DOCUMENT CHANGE REQUEST

DCR number 266 Changes required for: General

Title: Transistors Low Power RF NPN, based on type 2N3019

Number: 5201/011

Metal Can Package (TO-39) - 3 lead

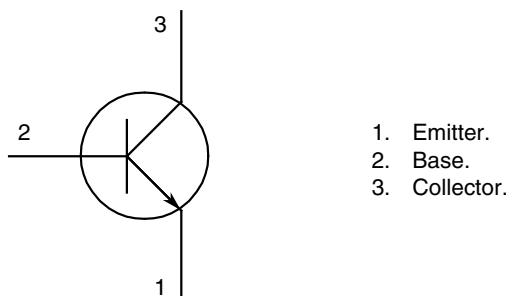
6. Figure 2 - Dimensions .a. and .b. corrected from "NOMINAL" to "BSC". The drawing harmonized with TO-39 outlines for similar STM components.
7. Para 4.3.2 - Weight requirements moved to Component Type Variants table.

VOLTAGE WAVEFORMS

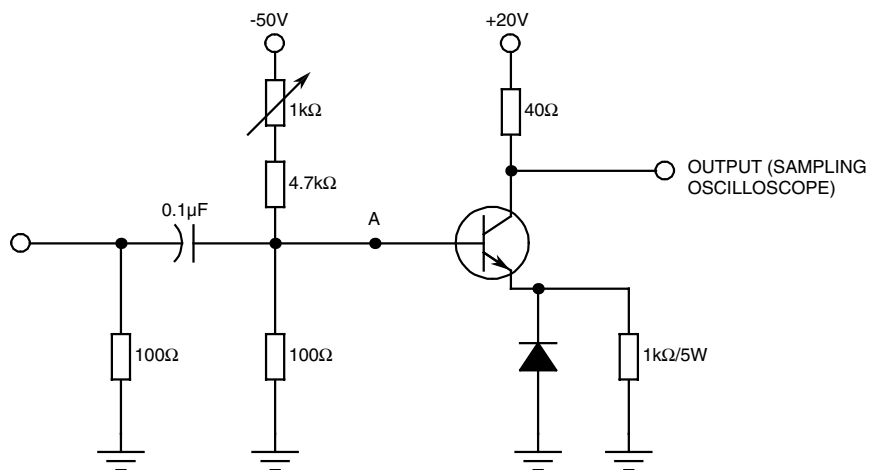
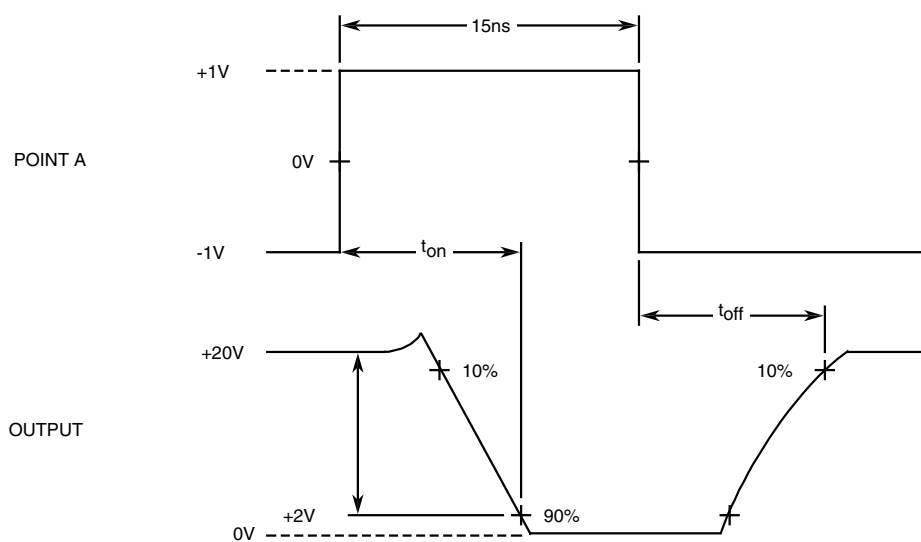
14. Table 2 . The test condition for tCB corrected from VCE to VCB to align with the MIL specification test definition.
 15. Table 2 and Figure 4 - For tON and tOFF tests a new Note 4 added which fully defines the tests based upon the test circuits and conditions used by STM and MIL specification, showing the test circuit and the corrected waveforms.
